Weir Phillips Heritage and Planning

WOLLONGONG CITY COUNCIL SSD-73910208 REQUEST FOR INFORMATION

This Heritage response has been prepared to accompany a Request for Information from Department Planning, Housing and Infrastructure to the SSDA – 73910208 for the site at Nos 6-8 Popes Road, Woonona, New South Wales. The SoHI letter has specifically addressed the proposed works to the former Woonona Church on the site.

Figure 1: Existing floor plan of the former Church. Breath Architecture. WPH overlay, illustrating Principal and Secondary Halls that comprise the former Church.

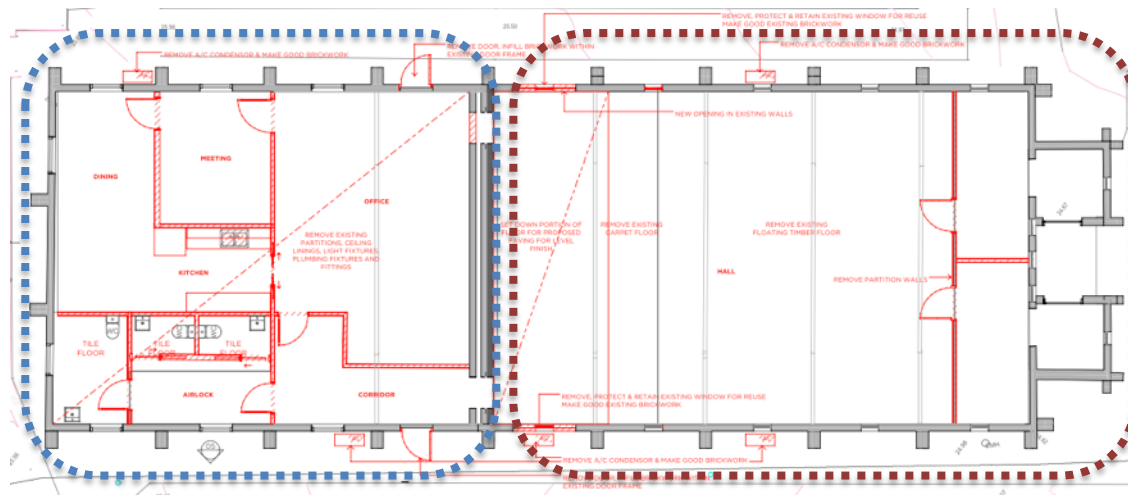
<p>obscured view corridors to the Church in this location and maintain the existing church setting and presentation from the public domain.</p> <p>Building D has been carefully designed in the context of the Church with a varied palette of materials, colours and restrained architectural detailing to enable able to sit comfortably with but recessive to the contrasting character and style of the Church.</p>
5	<p>RFI</p> <p>Adaptive reuse of heritage item</p> <p>13. The Department notes that limited information is provided about the internal fit out of the local heritage item for adaptive reuse as a restaurant / cafe. Please confirm the intended planning pathway for approval related to the design, fit out and operation of this space.</p>
5	<p>RFI RESPONSE</p> <p>IRT is requesting for approval in the SSDA for the adaptive reuse of the church building for a restaurant and café.</p>
6	<p>RFI</p> <p>The EIS and HIS notes that internal reconfiguration and demolition works are proposed to the Church building to support a change of use to a restaurant and all fit out and services will be reversible.</p> <p>However there are no plans or detail of what work is proposed to the church building, how the additional pavilion and kiosk would function, what is proposed to be accommodate in the church building (kitchen, storage, dining etc). Floor plans and demolition plans are requested for the heritage item, and additional structures.</p>

6	<p>RFI RESPONSE</p> <p>The architectural drawings have now been revised to include plans and detail of the work proposed to the church building to adaptively re-use it as a restaurant and cafe, how the additional pavilion and kiosk will function, what is proposed to be accommodated in the church building (kitchen, storage, dining etc). Floor plans and demolition plans of the heritage buildings are now provided. Refer to the revised SSDA submission.</p> <p style="text-align: center;">Impact of the Proposed Works on ‘Former Woonona Uniting Church’</p> <p>The Former church is comprised of two attached halls, the principal front hall and rear, secondary hall. Refer to Figure 33.</p> <div style="text-align: center;">  <p>The floor plan shows the layout of the church building, divided into a Secondary Hall (left) and a Principal Hall (right). The Secondary Hall contains a Dining area, Meeting room, Office, Kitchen, Airlock, and Corridor. The Principal Hall contains a Hall and a Corridor. The plan is annotated with red lines and text indicating proposed demolition and construction work, such as 'REMOVE EXISTING PARTITIONS, CEILING, LINEN, LIGHT FIXTURES, PLUMBING FIXTURES AND FITTINGS', 'REMOVE EXISTING CARPET FLOOR', 'REMOVE EXISTING FLOATING TIMBER FLOOR', and 'REMOVE EXISTING WINDOW FOR REUSE MAKE GOOD EXISTING BRICKWORK'. A blue dashed line outlines the perimeter of the building, and a red dashed line outlines the perimeter of the proposed works. Labels 'SECONDARY HALL' and 'PRINCIPAL HALL' are placed below the plan.</p> </div>

- The principal significance of the hall interior is its internal volume created by the raked timber ceiling and arched windows which are retained.
- The proposed works to principal hall are minor in scale including the removal of the contemporary partition walls and rooms to the front of hall, near the entry and will help reinstate the original open plan of the hall.

- The partitions walls will be carefully removed to ensure there is no damage to any significant fabric.
- The two arch windows proposed to be removed will be carefully removed, protected and securely stored on site. It is also possible that they could be displayed within the church. The new openings created by the removal of the windows will enable compliant access to the proposed pavilions and will be carefully undertaken removing as few bricks as possible and openings made good with new joinery.

- The secondary hall has been previously modified with a lowered ceiling and internal rooms to half of the hall.
- The proposed ceiling will extend the existing lowered ceiling to all of the secondary hall with the more significant raked ceiling retained above.
- The removal of the internal layout and joinery is either contemporary and less significant. It will be carefully removed to ensure no damage to the heritage fabric.
- Self-supporting stud walls will be constructed adjacent to the significant heritage walls to enable the installation of new joinery, hydraulic and electrical services to prevent any physical impact on the heritage walls.
